Your reference: MCU/2020/5051 & RAL/2020/5054

**RE: FURTHER ADVICE RESPONSE – TRAFFIC ENGINEERING ITEMS
PROPOSED RESIDENTIAL SUBDIVISION AT 689 TOOWOOMBA CECIL PLAINS ROAD**

FURTHER ADVICE
Planning Act 2016 Section 68
Development Assessment Rules Section 35

Figure 3.1: Catchment Analysis – Estimated Daily Link Volumes

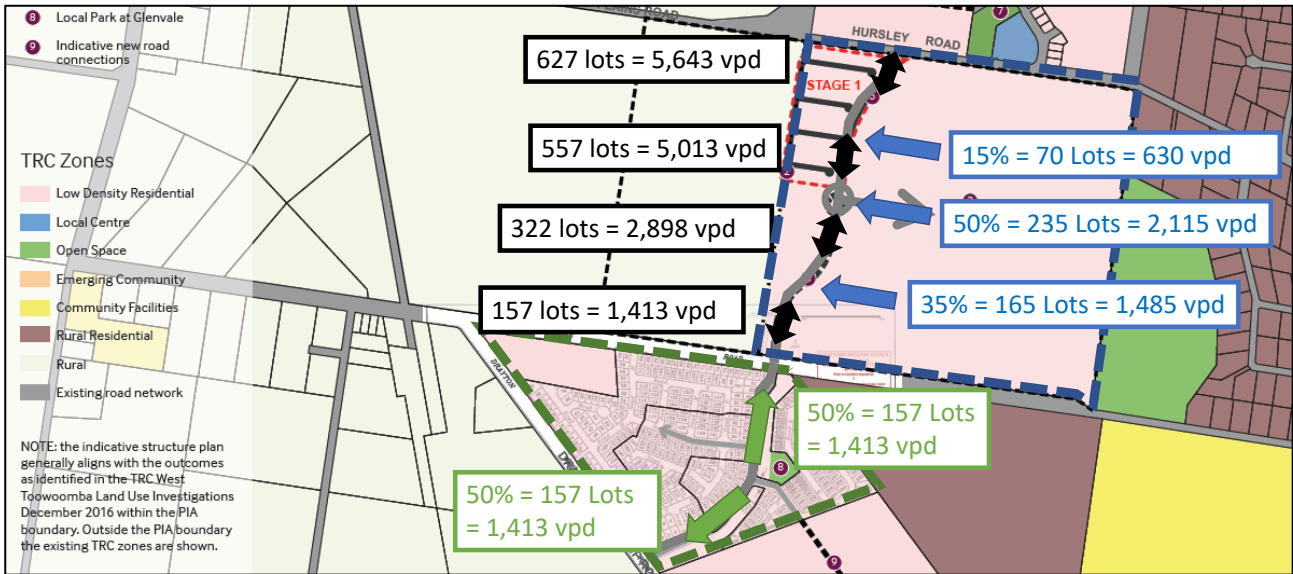
<p>1.1 Aspect of Development: Road Hierarchy</p> <p>The supplementary traffic advice states only low levels of internal traffic will distribute from future urban land to the west onto the north/south road proposed through the development site. Toowoomba Cecil Plains is a State-controlled road and when development occurs on the western site there is no guarantee multiple accesses will be allowed, given there are local government roads that can provide alternative access arrangements. Therefore, more traffic is likely to use the north/south road and a distributor hierarchy status is relevant for the east/west collector street and along the north/south road to Hursley Road.</p>
<p>Further Information Required:</p> <p>Please amend the Indicative Structure Plan to include:</p> <ul style="list-style-type: none"> • An east/west distributor road connection; and • A distributor road connection from the east/west road to Hursley Road.

As per SC6.2.2.2.4 of Council’s Planning Scheme, a Distributor Road hierarchy is suitable to accommodate traffic volumes above 300 Lots per day (based on the threshold of Collector Roads). Based on the revised lot layout provided, Figure 3.1 illustrates the estimated daily link volumes along the internal road network (based on a total development yield of 470 residential Lots). In summary:

- The North/South Road south of the East/West Collector Road is estimated to accommodate up to 322 lots OR 2,898 daily trips based the proposed development and Thurgoona Development
- The North/South Road north of the East/West Road may ultimately accommodate 627 lots OR 5,643 daily trips (at the connection to Hursley Road)
- This does not consider any developments within the PIA that are not approved and may be subject to increases based on future development within the currently defined PIA.

Based on the above, the estimated ultimate yield (>300 lots) is consistent with Council’s requirements for a Distributor standard road, for the length of the North/South Road.

In summary, the proposed hierarchy of the North/South Road as a Distributor standard road between Hursley Road and Devine Road is in accordance with Council’s Planning Scheme requirements and is expected to be suitable to accommodate the full development of the catchment. This also allows for a level of future proofing once additional development to the south (within the PIA) occurs.

Figure 3.2: Refuge Island Layout

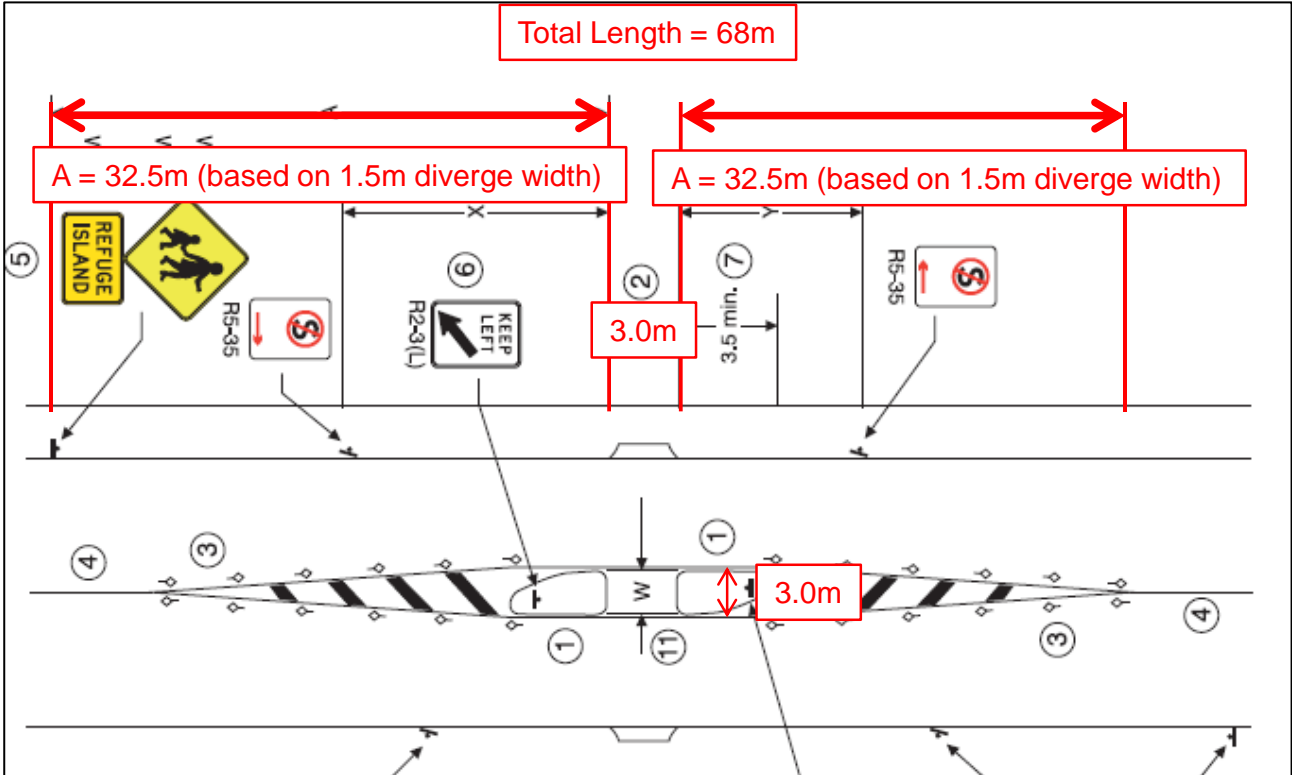
<p>1.5 Aspect of Development: Pedestrian and Cycle Connection</p> <p>The supplementary traffic advice states active transport connections can be conditioned. Council requires proof of concept for how the connection will be made including the provision of a pedestrian/cycle refuge on Hursley Road.</p>
<p>Further Information Required:</p> <p>Please provide plans showing how a 2m wide path connection could be provided on Hursley Road from the development access intersection to the Sovereign Hills development including a 3m wide pedestrian/cycle refuge on Hursley Road as per MUTCD Part 9 Figure 3.7.3.</p>

The provision of a refuge island 3.0m wide can be provided along Hursley Road to accommodate pedestrian and cyclist demands.

It is noted that Figure 7 of MUTCD Part 10 states that a 2.0m wide minimum treatment may be suitable where there are not high volume pedestrian or cyclist demands. Given the location of the crossing on the edge of the urban area, it is expected that demands will be low and a 2.0m wide treatment would be appropriate. However, at this initial stage, we have considered a 3.0m treatment.

The provision of the refuge will have a footprint of 68m in length including the provision of a 32.5m lateral movement (based on 1m/second lateral movement) as shown in Figure 3.2.

Figure 3.3: Access Intersection 2039 Volumes

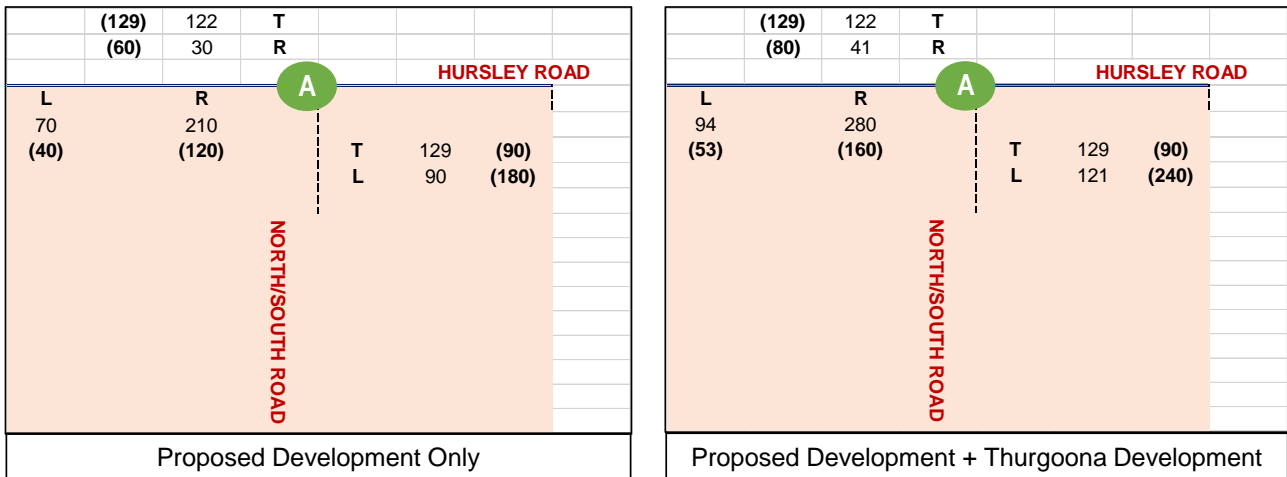
The supplementary traffic advice has analysed the Hursley Road/Site Access at the 10-year design horizon (2039) for the ultimate 470 lots. However, the analysis does not allow for a 1% traffic growth rate on Hursley Road or traffic from existing approved development to the south.

Please confirm the development access tee intersection treatment has sufficient capacity for the ultimate development including 1% pa traffic growth on Hursley Road and the traffic likely to use the north/south development access when connected to land south of the development site. Please confirm the auxiliary lane treatment required to accommodate ultimate development under the above scenario.

Figure 3.3 presents the estimated ultimate traffic volumes at the intersection. This includes:

- 1% growth rate along Hursley Road to a 2039 design horizon
- Traffic from 470 Development Lots with a trip generation of 0.85 trips per lot
- Traffic from 157 Lots of the Thurgoona Development (i.e. 50% approved yield) with a trip generation of 0.85 trips per lot (in Scenario 2)
- Consistent distribution for all lots has been adopted as per the TIA.

Based on the above, a full length CHR treatment is required at the Hursley Road / North/South Road intersection to accommodate the entire catchment. This is proposed to be provided in accordance with Austroads GTRD Part 4A and will include a minimum length of 110m (including tapers).
